Project Manager  
 Drawn By  
 Checked By  
 Date **5-30-86**  
 Project Number  
**84129**

**SITE PLAN AMENDMENT** 1986-83  
**WESTBURY CROSSING**  
 FOR: JOHN CROSLAND Co.  
 APPROVED BY CITY COUNCIL  
 DATE 8-18-86

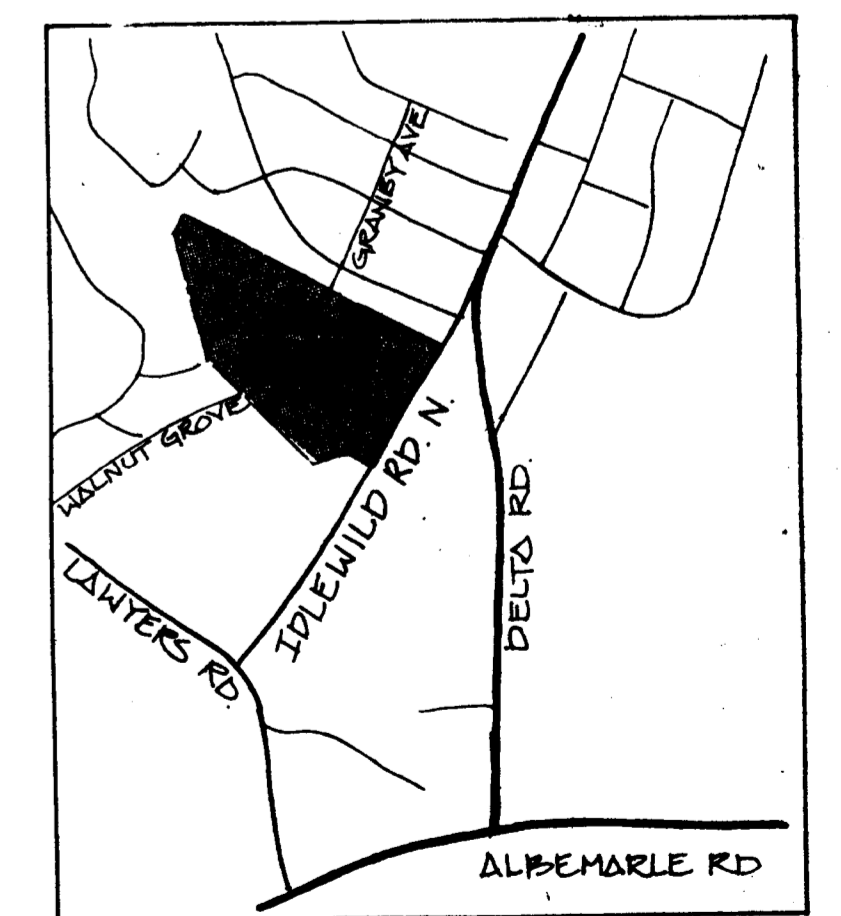
- NOTES:**
- NO VEHICULAR CONNECTION FROM MULTI-FAMILY TO SINGLE-FAMILY PORTIONS WILL BE MADE.
  - NO MORE THAN ~~TWO~~ <sup>THREE</sup> POINTS OF ACCESS WILL BE PROVIDED ONTO IDLEWILD ROAD NORTH.

\* NOTE: THE ONLY CHANGE PROPOSED BY THIS SITE PLAN AMENDMENT IS A REVISION TO NOTE #2 WHICH WOULD ALLOW THREE POINT ACCESS TO THE MULTI-FAMILY LAND INSTEAD OF TWO.
